RFI FORM

| REQUEST FOR INFORMATION (RFI) | | | |
|---|-------------------|-------------------------------|--------------------------|
| PROJECT NUMBER: | 600-13-114 | RFI NUMBER: | 001 |
| PROJECT NAME: | Upgrade Restrooms | DATE REQUESTED: | 11/07/2014 |
| SOLICITATION NUMBER: | VA-262-15-B-0044 | REFERENCE: | Resinous Epoxy Base Spec |

UL924 Enclosed 20 AMP Bypass Shunt Relay

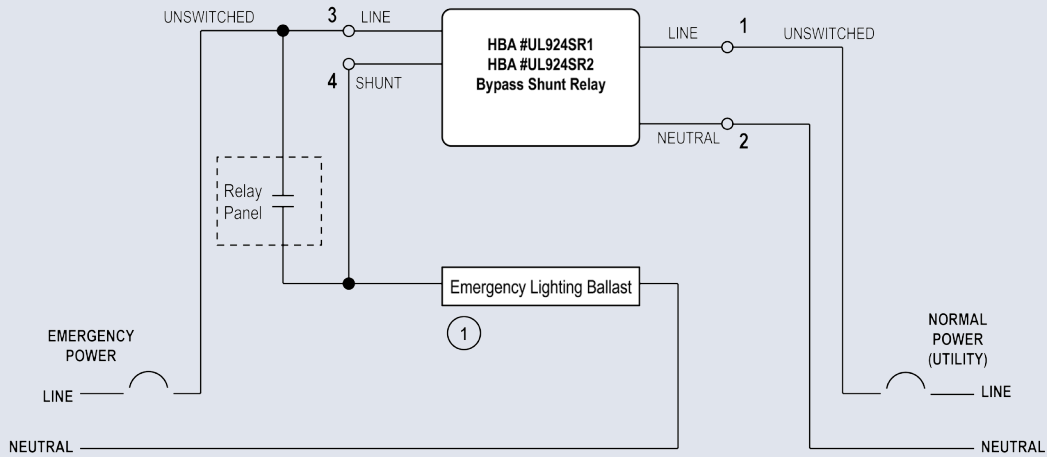
6. What is the warranty period for this project?
1 year
7. Need manufacture and model number of shunt relay.
Refer to attached cutsheet 6001a-ul924-sr-cutsheet.

Hubbell Building Automation's enclosed 20 Amp electrically held UL 924 Bypass Shunt Relays provide an isolated normally closed contact that can be used to provide bypass shunt to power emergency egress lighting directly from the emergency generator source. The coil in these relays is powered by a normal power supply.

When the loss of commercial power occurs, the contact returns to its normally closed state and bypasses control to the emergency egress lighting. These fixtures will remain connected directly to generator emergency source until transfer back to normal power occurs.
